ADDENDUM NO. 1

Renovate Sub (Acid) Lab Missouri Geological Survey (DNR) Rolla, Missouri

PROJECT NO.: W2001-01

RENOVATION **FLOOR PLAN**

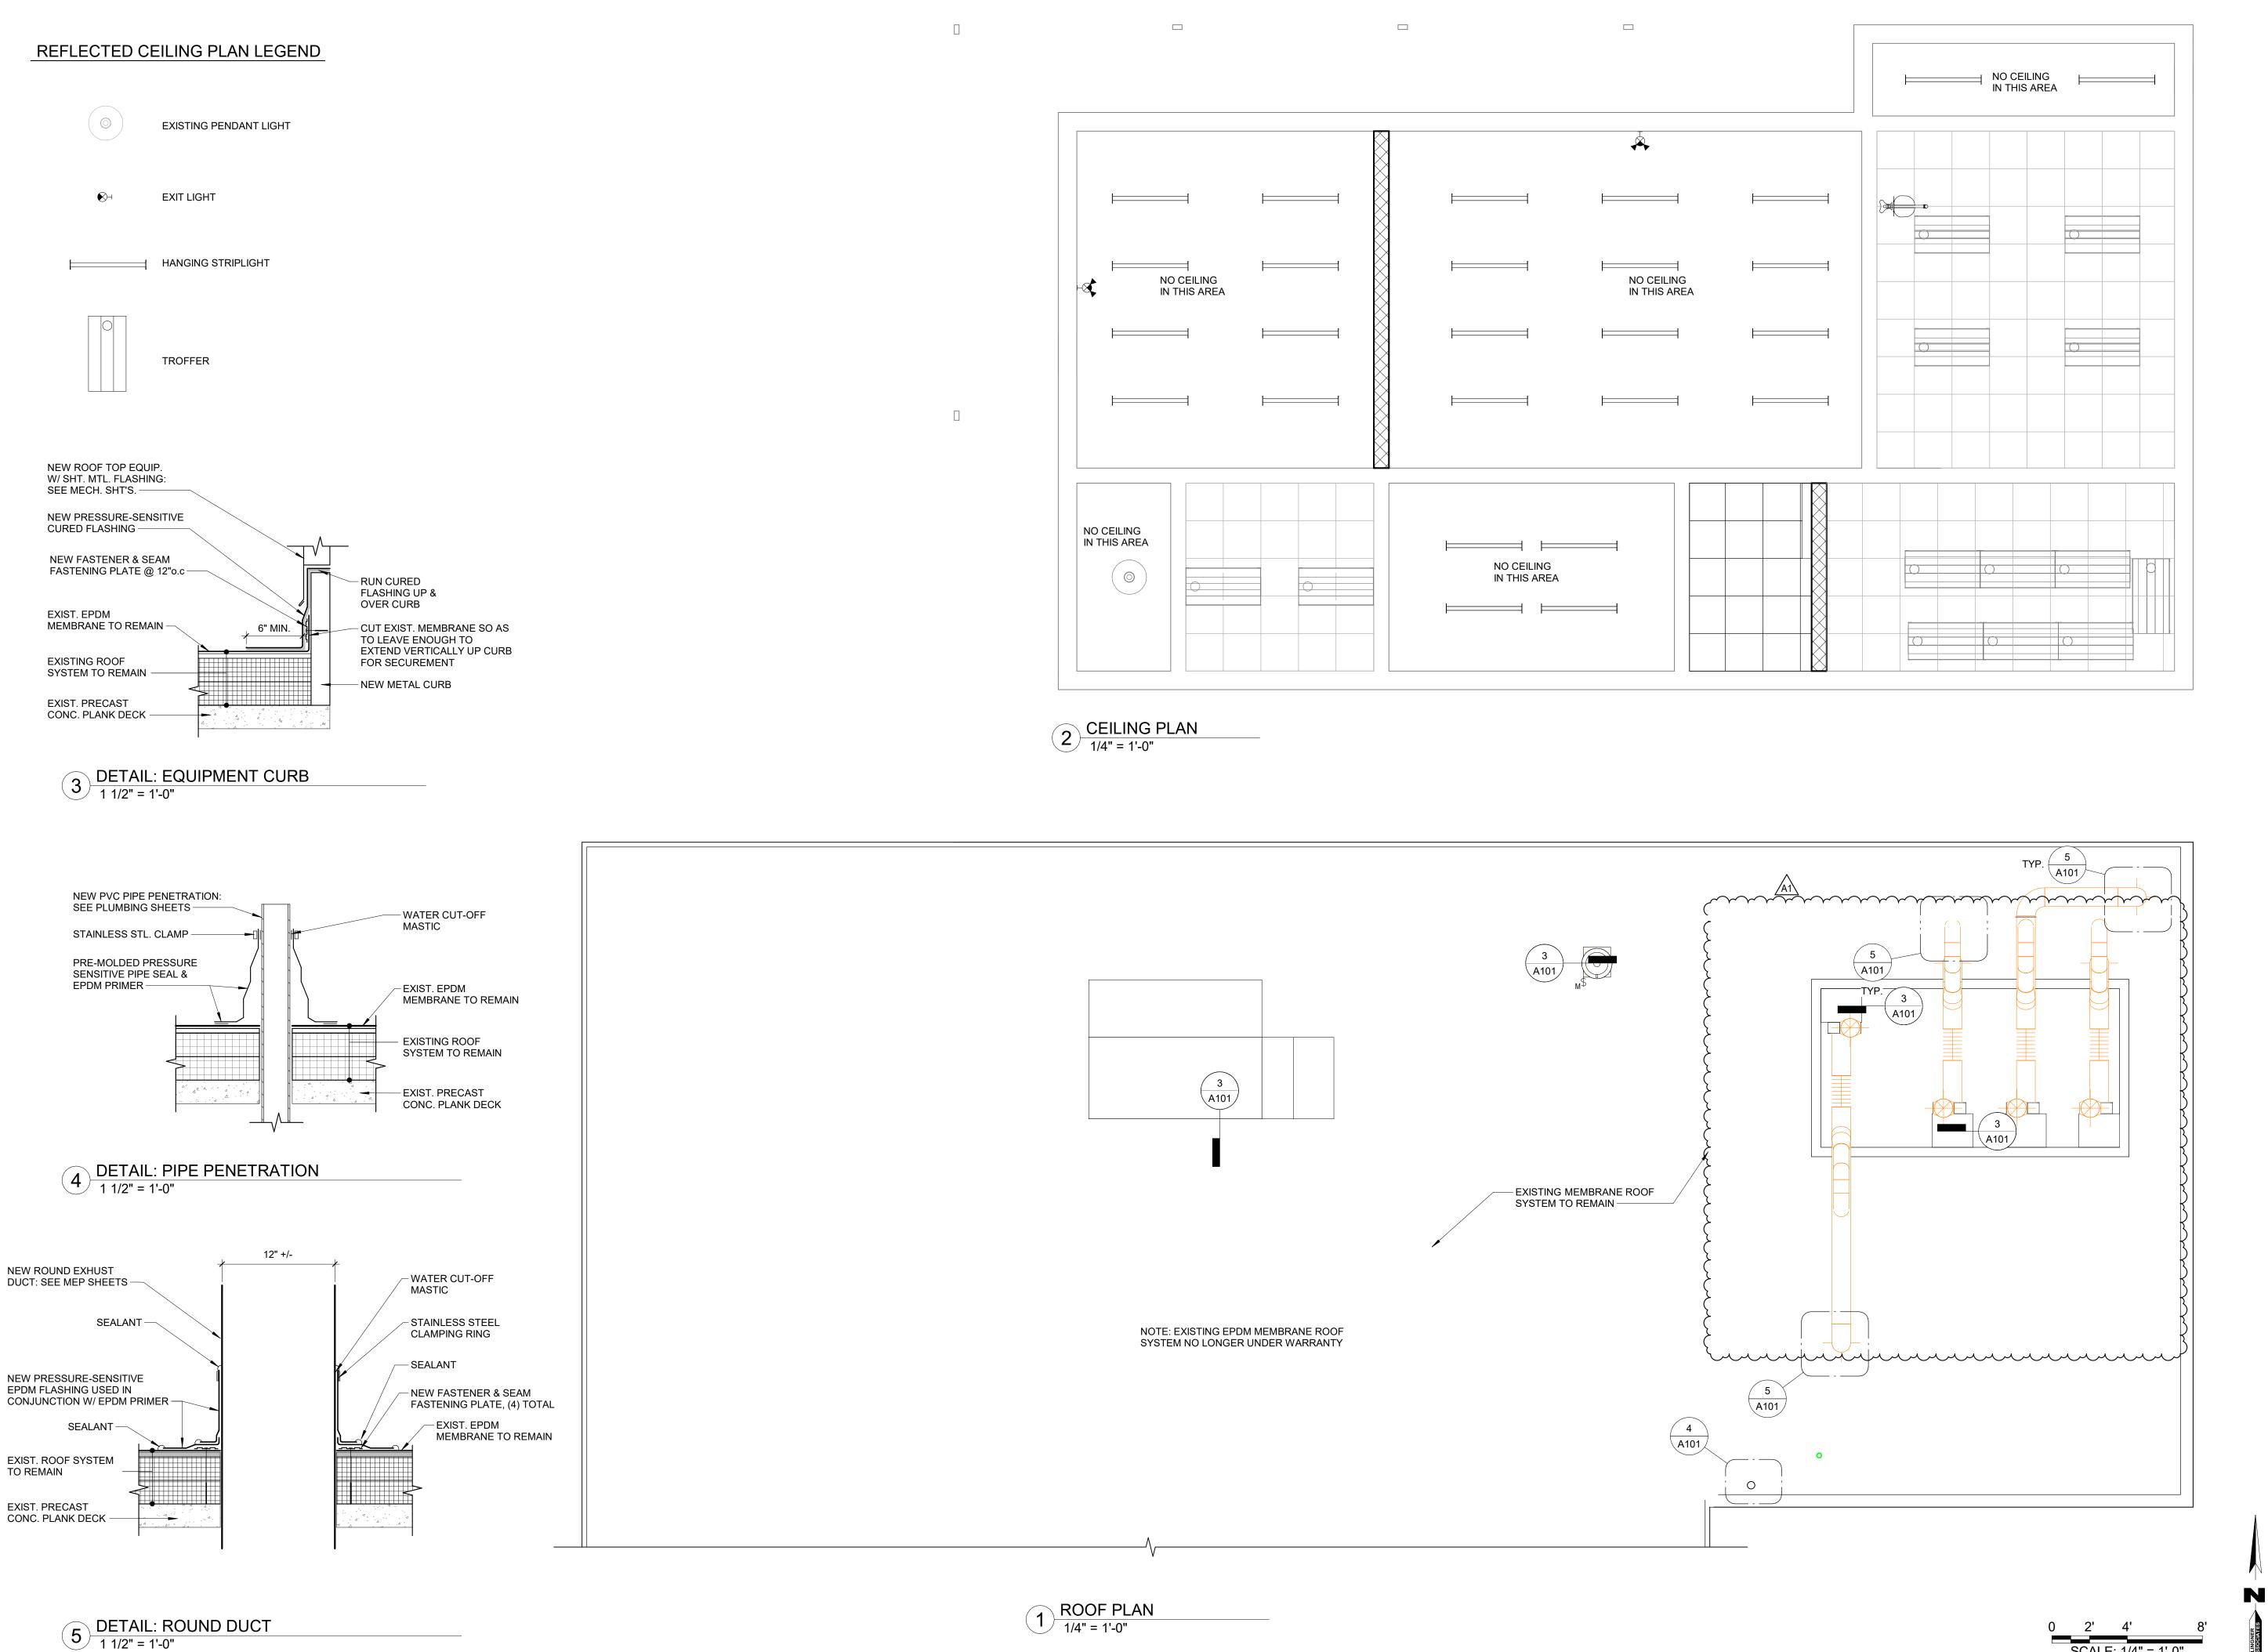
- a. REVISE Room 104 name to Inert Storage and Room 107 to Conodont Lab
- b. REMOVE Hood and Cabinetry from Room 104
- c. ADD Hood and Cabinetry to Room 107
- d. ADD Detail 6/A100
- e. ADD Detail 7/A100
- f. REVISE Detail 2/A100
 - i. Show 4" x 4" x 5/16" angles
 - ii. Add Hollow Metal Frame Note: HM FRAME (USE FRAME W/ 3/8" FLAT HEAD EXPANSION BOLT ANCHORS)
 - iii. Add Note: DOOR OPENINGS: GROUT EXISTING CAVITIES FULL FOR HEIGHT OF TWO COURSES AND 10" BEYOND JAMB FOR 10" BEARING
- g. REVISE Detail 3/A100
 - i. Add note: HM FRAME (GROUT SOLID OR USE PUNCH & DIMPLE FRAME W/ 3/8" FLAT HEAD EXPANSION BOLT ANCHORS)
- h. REVISE Door and Frame Schedule Door 105B Head Detail to 6/A100

- i. REVISE Door and Frame Schedule Door 105B Jamb Detail to 7/A100
- i. Revised sheet is attached.

**ENLARGED** TOILET PLAN & **ELEVATIONS**

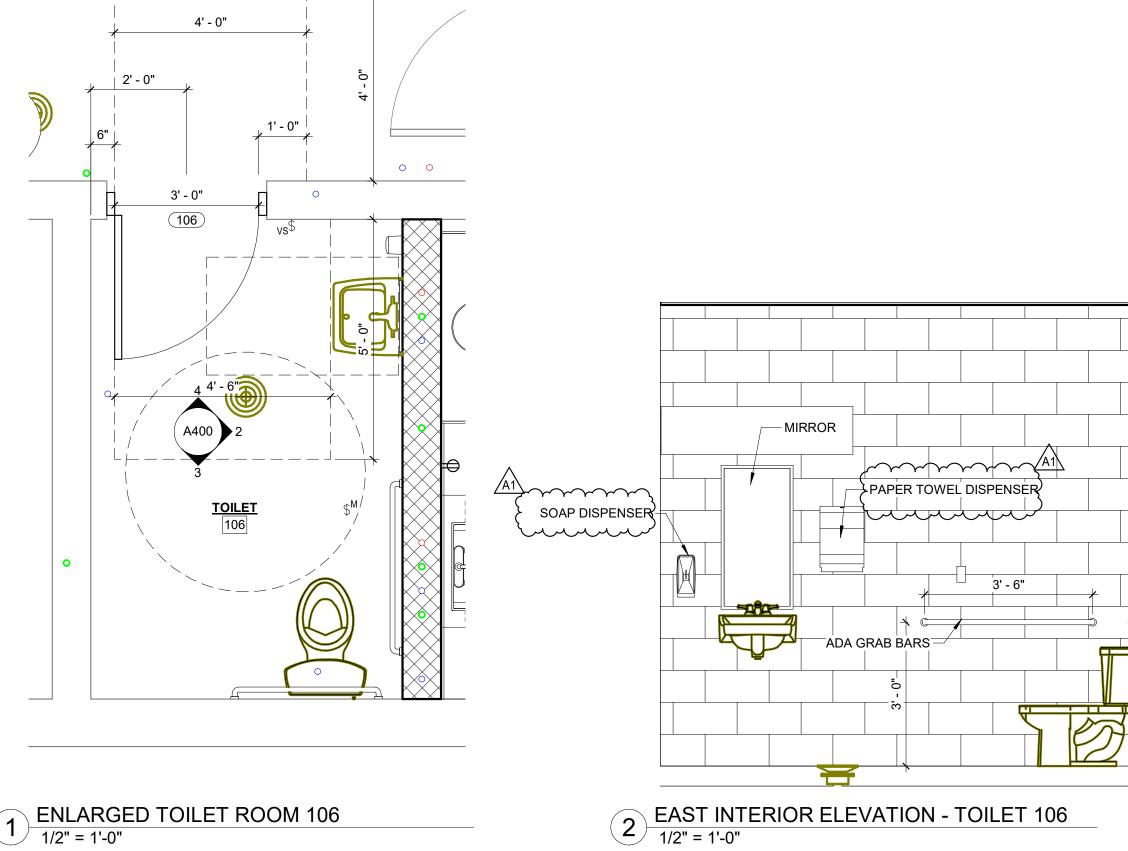
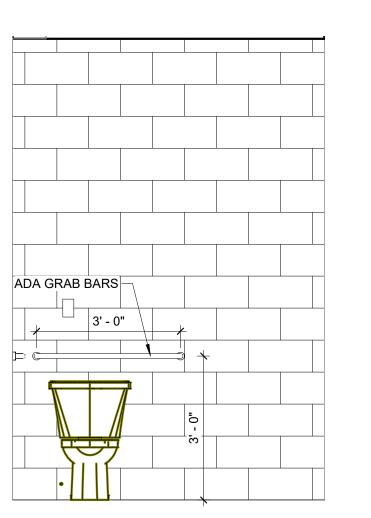
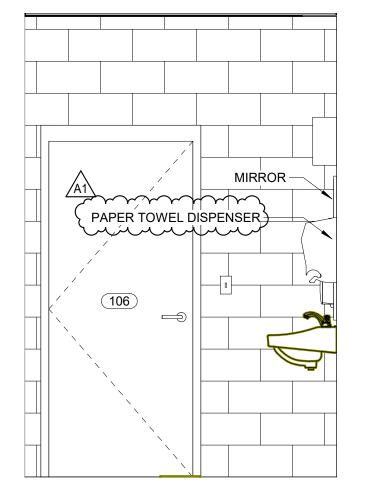
- a. REVISE Detail 2/A400
 - i. Add Paper Towel Dispenser and Soap Dispenser
- b. REVISE Detail 4/A400
 - i. Add Paper Towel Dispenser and Soap Dispenser
- c. Revised sheet is attached.

**FLOOR FINISH** PLAN & **SCHEDULES**

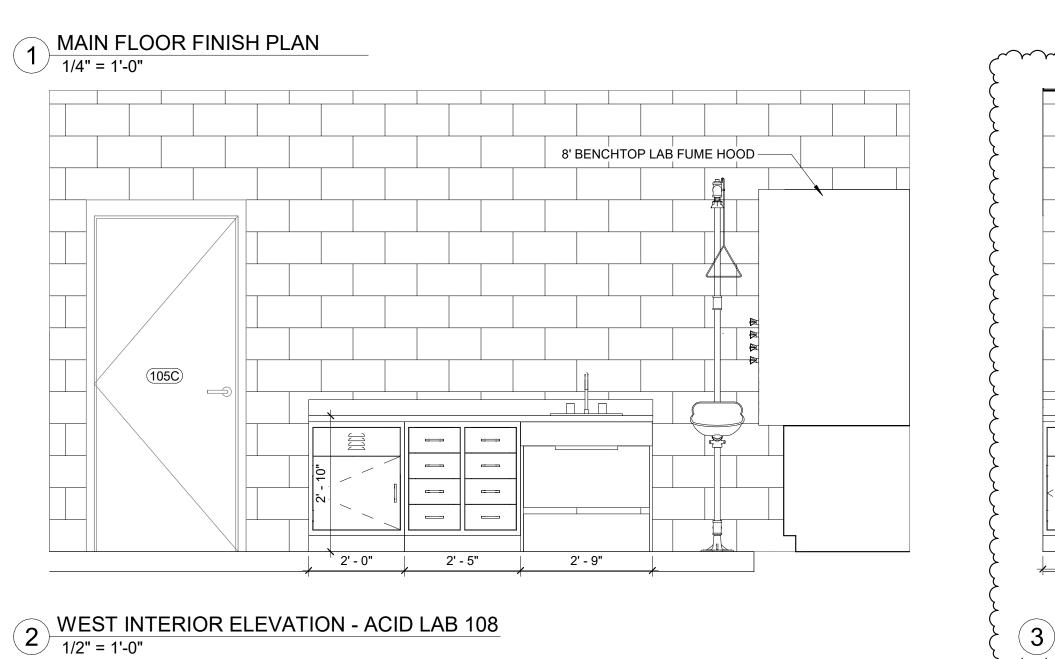
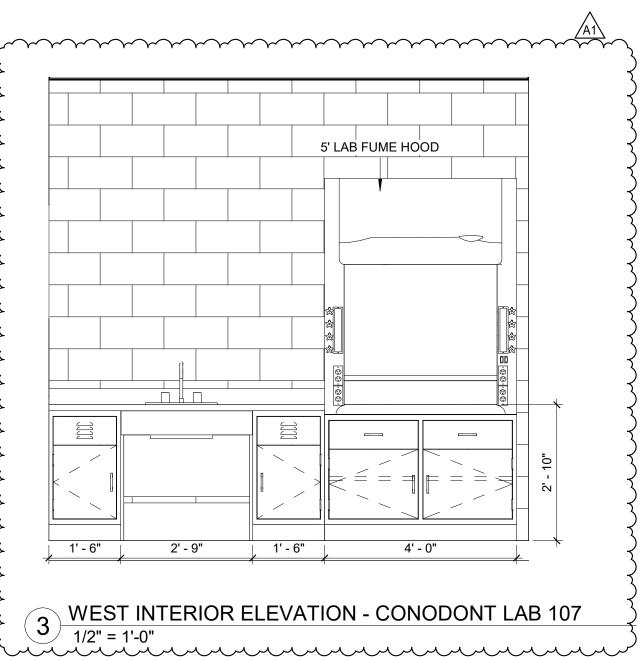
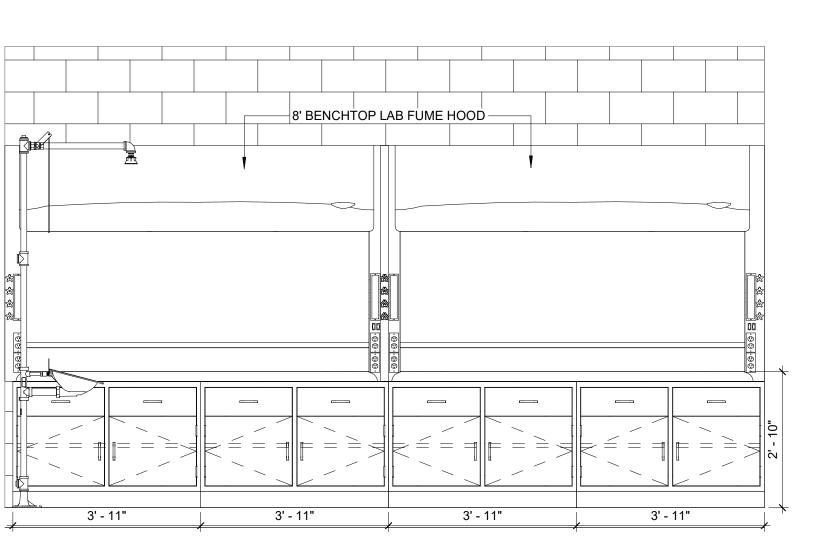
- a. REVISE Detail 3/A700
 - i. Change Elevation Location to Room 107
- b. REVISE Room 104 name to Inert Storage and Room 107 to Conodont Lab
- c. REMOVE Hood and Cabinetry from Room 104
- d. ADD Hood and Cabinetry to Room 107
- e. ADD PNT-2 to Walls Schedule for all newly exposed metal deck and bar joists
- f. Revised sheet is attached.

CAD DWG FILE: A800
DRAWING BY: JRT
CHECKED BY: HMC
DESIGNED BY: JRT

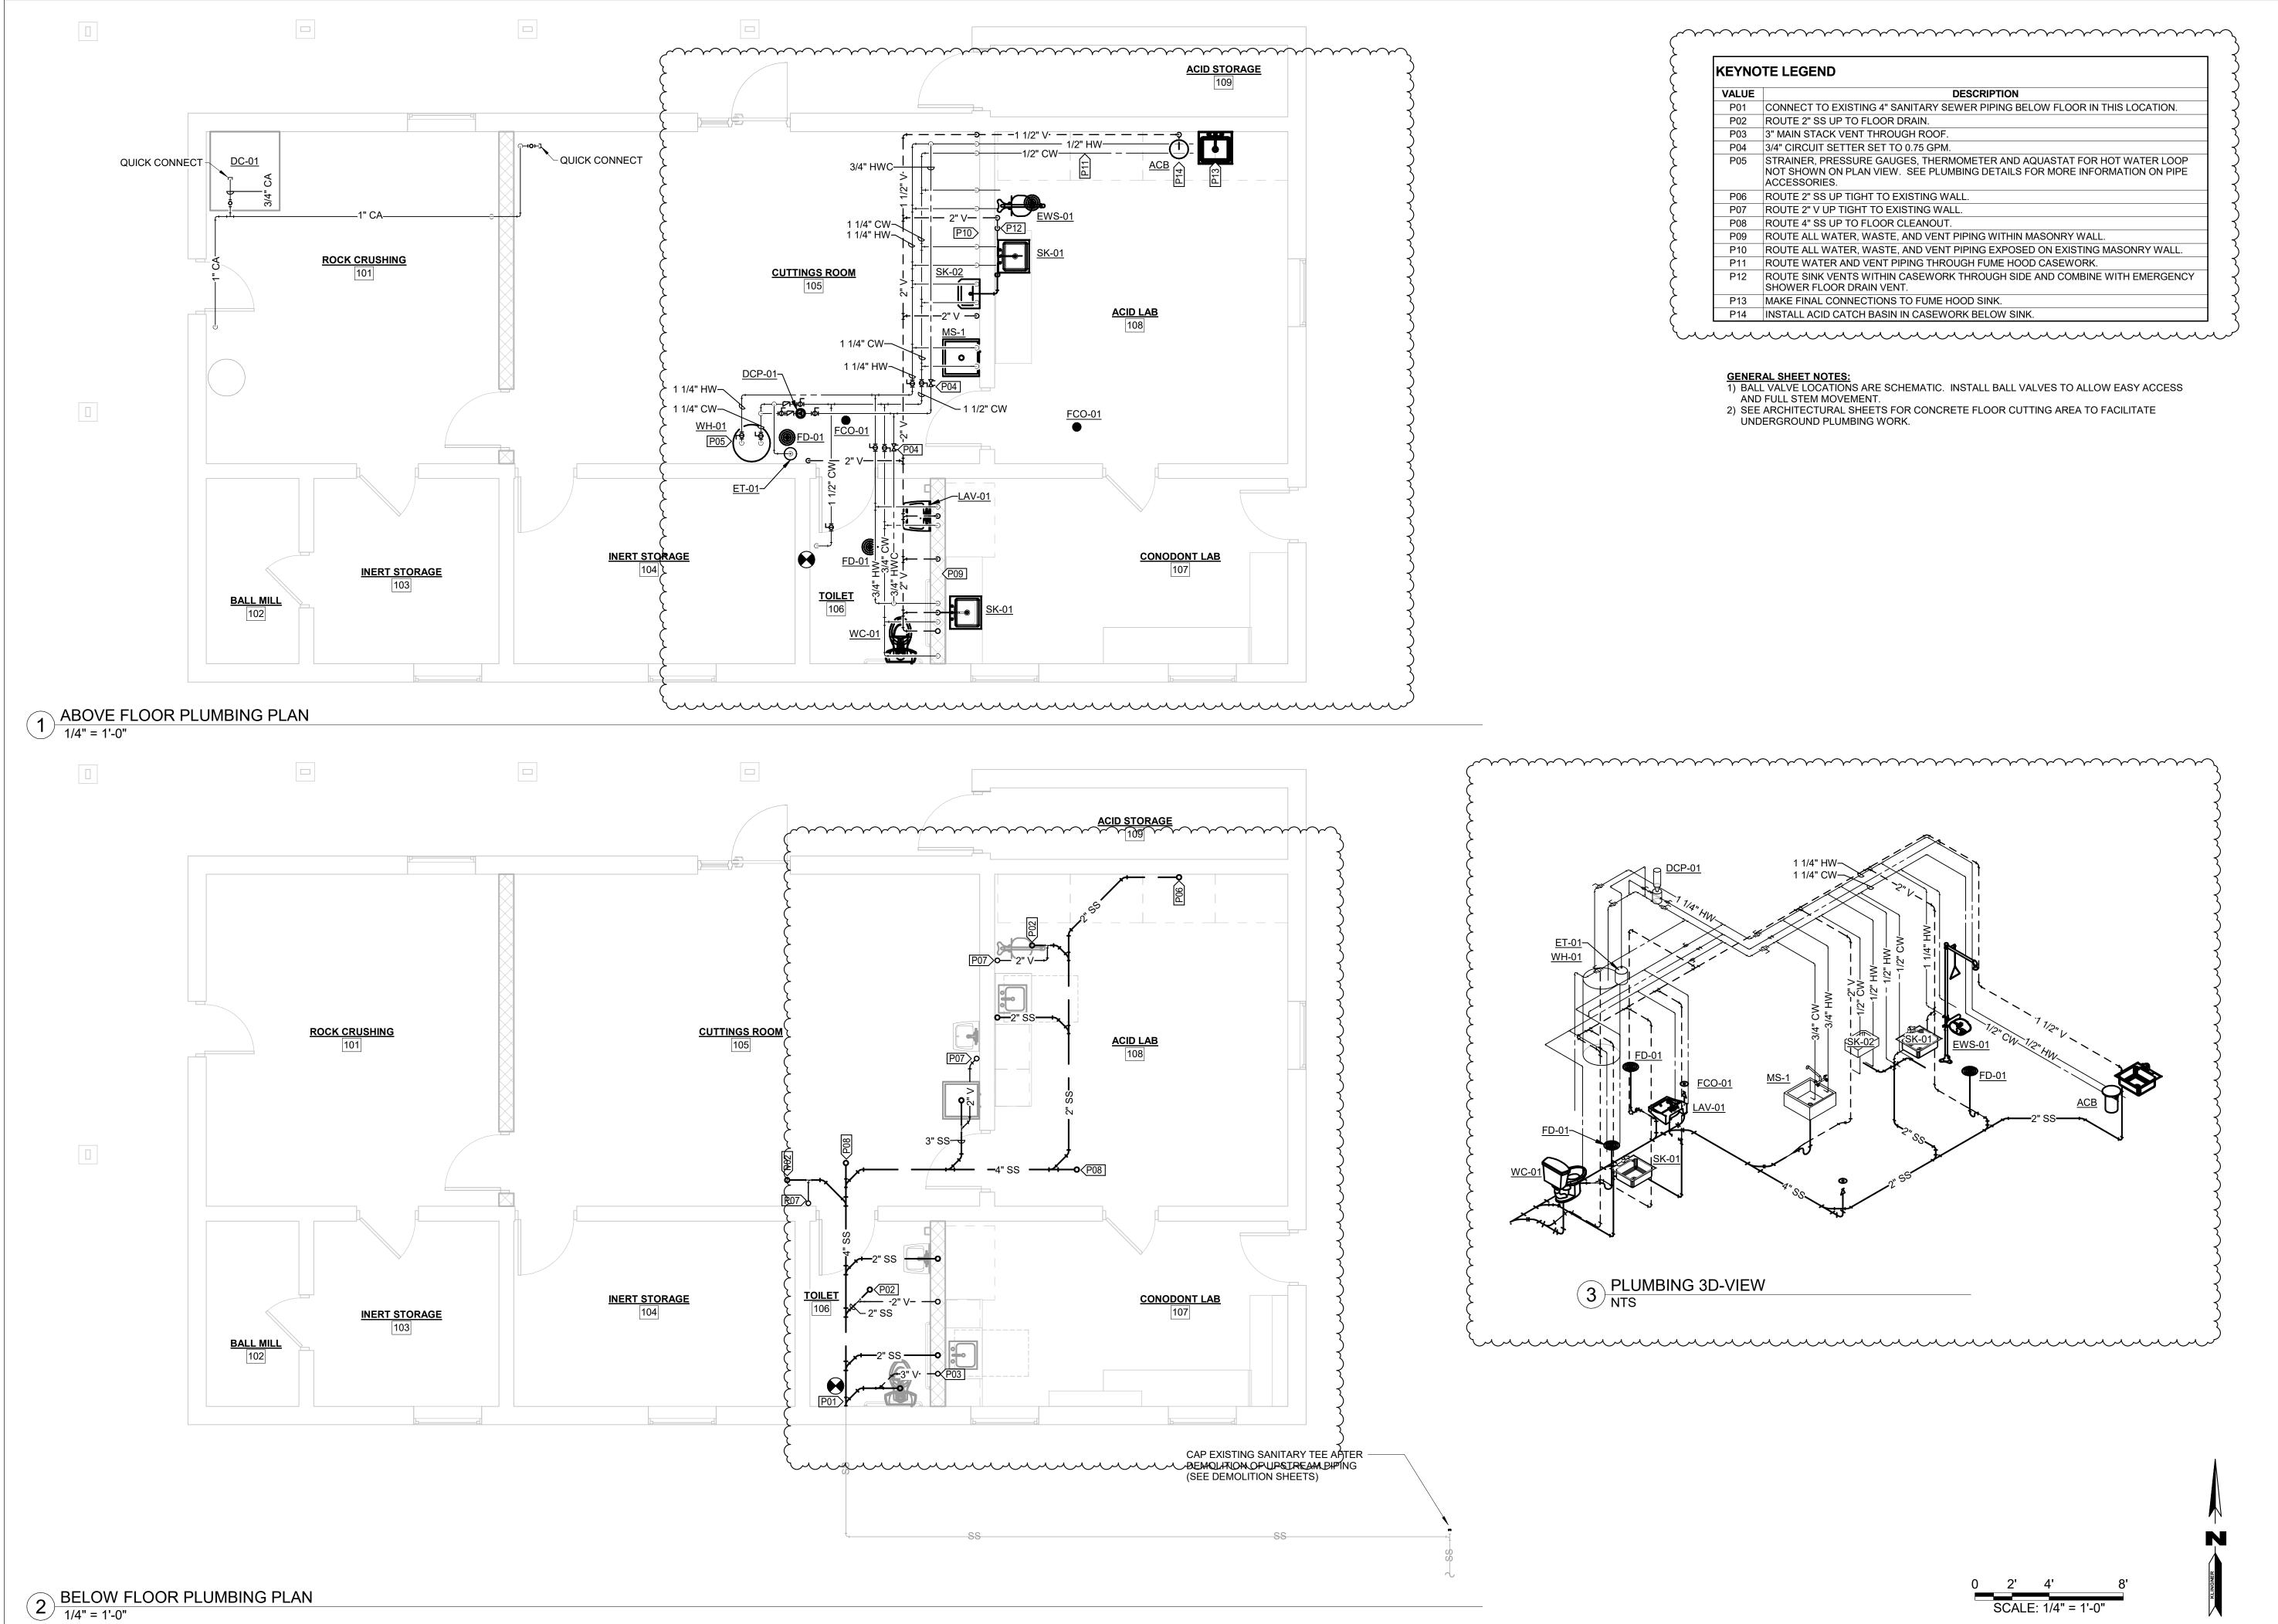
- a. REVISE 3D view location for Conodont Lab
- Revised sheet is attached.
